# UNITED STATES PATENT AND TRADEMARK OFFICE

10/581,021

<b>Office Action Summary</b>	Application No. 10/581,021	Applicant(s) KIM ET AL.	
	Examiner Joshua Benitez	Art Unit 2829

### **DETAILED ACTION**

Fig. 1

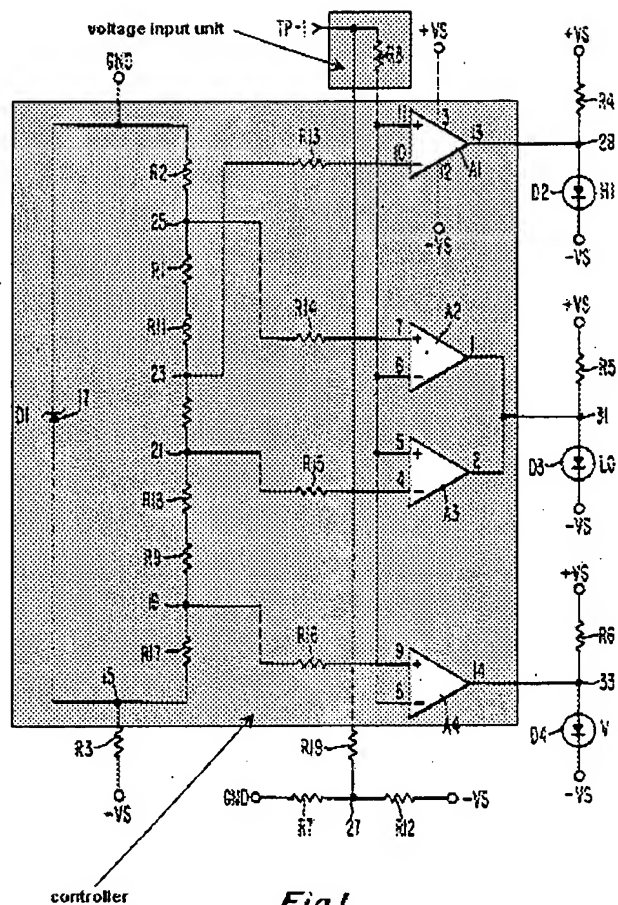
In re claim 1, Shintaku '673 discloses in figures 1-3 a portable electric testing equipment (45) comprising:

- a probe (TP-1);
- ground contact means (43, fig. 2);
- a voltage input unit for receiving a voltage applied from said probe;
- a controller for applying a test voltage of a prescribed level to said voltage input unit (col. 2, lines 39-56); and
- outputting a control signal for indicating a ground (MIDRANGE) when a voltage level inputted from said voltage input unit is below zero level and for indicating a measurement stand-by state (OPEN, col. 3, lines 47-56) when the voltage level is a test voltage level and for indicating a detected voltage level (HIGH) when the voltage level is above a prescribed reference voltage (col. 2, lines 26-37); and

display means (D2-D4) for performing an indication according to the control signal from said controller.

Regarding claim 3, Shintaku '673 discloses said display means comprises a plurality of light emitting elements (D2-D4), each being illuminated according to a detected voltage range (col. 2, lines 10-15).

With respect to claim 4, Shintaku '673 discloses said display means comprises a low voltage warning light emitting element (D4) for being illuminated when a voltage below said prescribed voltage is detected (col. 2, lines 24-25, 36-37).

FIG. 1

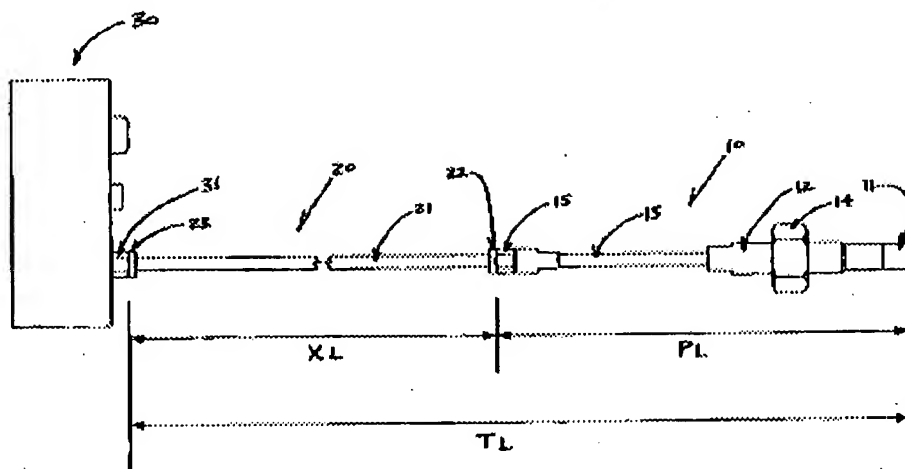
However, Ort '144 does disclose in figure 1 a test system comprising probe extension means (20) having an attachable/detachable coupling unit (22), an extension

cable (21) and an auxiliary probe (23) connected to said extension cable (21).

It would have been obvious to one having ordinary skill in the art at the time the invention was made to have provided the electric test equipment as taught by Shintaku et al with a probe extension means as taught by Ort et al in order to provide an extended distance between the user and the device being tested to give more freedom of movement for the portable device.

Fig.1

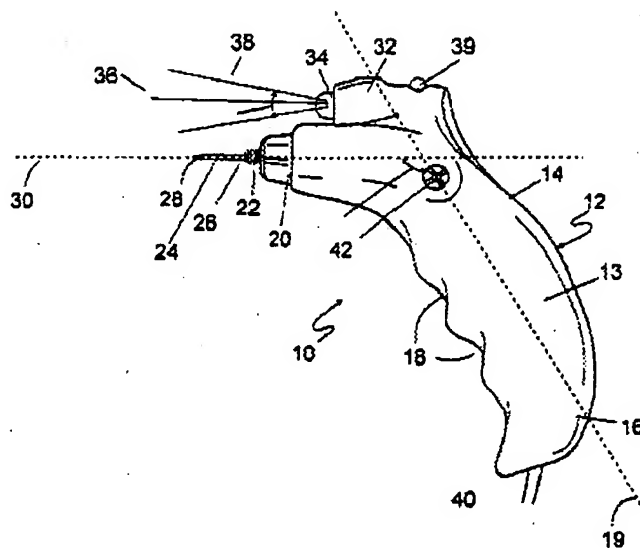
However, Vinci '964 does disclose in figure 1 a portable electric testing equipment (10) comprising an illuminating lamp (34) for illuminating a place at the pointing direction of said probe.

It would have been obvious to a person having ordinary skill in the art at the time the invention was made to have provided the test equipment as taught by Shintaku et al with an illuminating lamp as taught by Vinci et al in order to illuminate the work area in the region of the probe test point (col. 2, lines 36-38, 45-51).
